FFRDC Draft Report & NAS Review #3

Nuclear Waste Program

October 31, 2019

Federally Funded Research and Development Center (FFRDC) Study & National Academies of Sciences (NAS) Reviews

Figure 10-1. Basic flowsheet for full-scale ion exchange facility for removal of technetium (in its pertechnetate form) using the SuperLig[®] 639 resin.

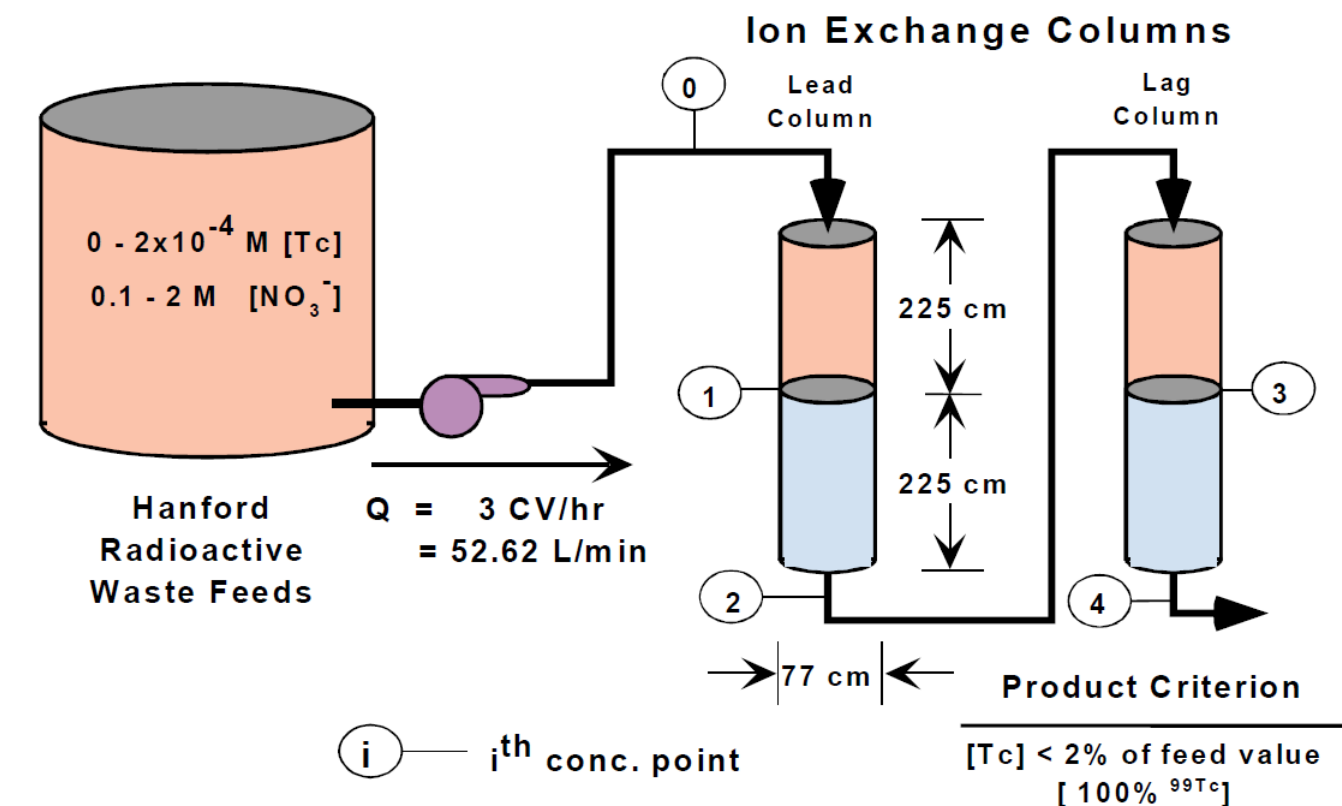
- IDF risk analysis for these two contaminants drives the treatment technology.
- A combined pretreatment and enhanced grout technology may be the best grout-based technology alternative.
- Missed opportunity – pretreatment alternative.
 - Tc-99 ion exchange pretreatment.
 - I-129 getter, e.g., layered bismuth hydroxides.
 - Allows the use of Portland cement based grout formulation.
 - Eliminate completion to maintain a reducing environment for Tc-99 retention within an otherwise oxidizing environment favorable to I-129 retention.

Figure F-16. Best Projected Cases for a) Tc-99 and b) I-129 for all three wasteform systems

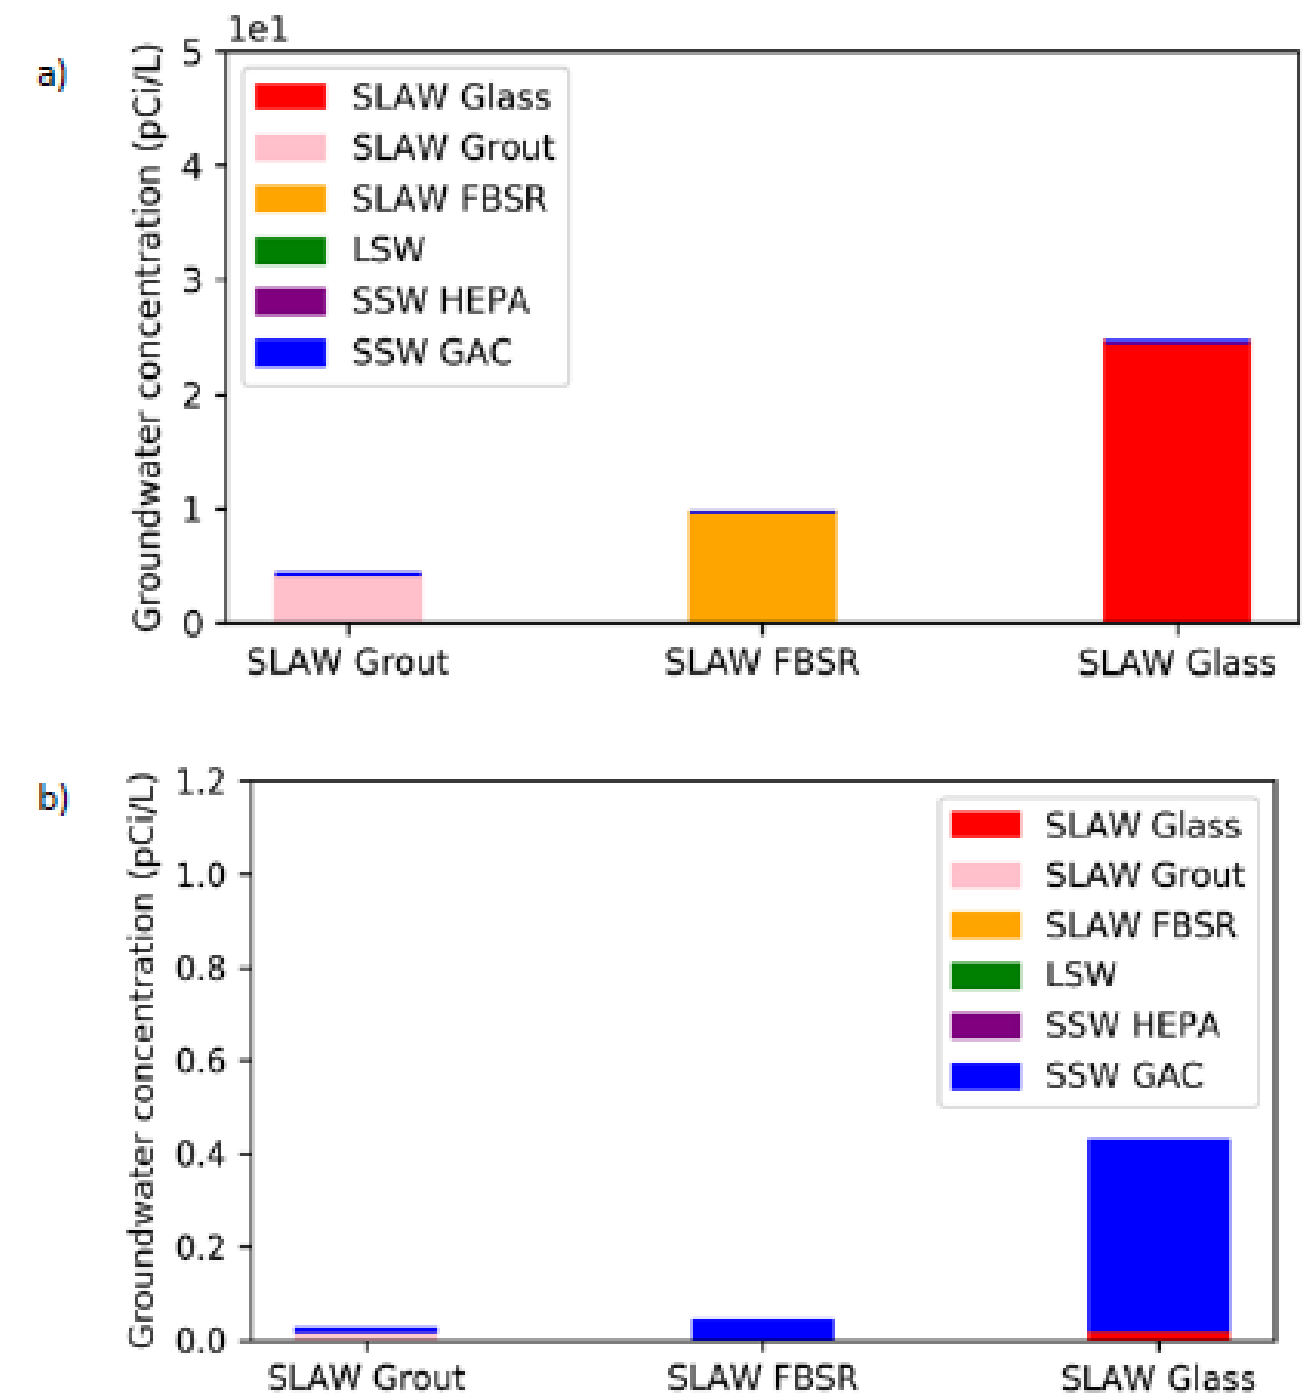
- “Best case grout” is still in R&D.
- Best case grout is not yet proven to meet regulatory waste form requirements for onsite disposal (despite what the FFRDC report might indicate).
- PNNL plans for continuing research appear to include verifying the waste form long-term durability and performance.
- Grout may be considered; however, groundwater must still be protected to the “good as glass” standard.

- Research result looks promising, but the waste form is not yet proven for onsite disposal at Hanford (despite what the FFRDC report might indicate).
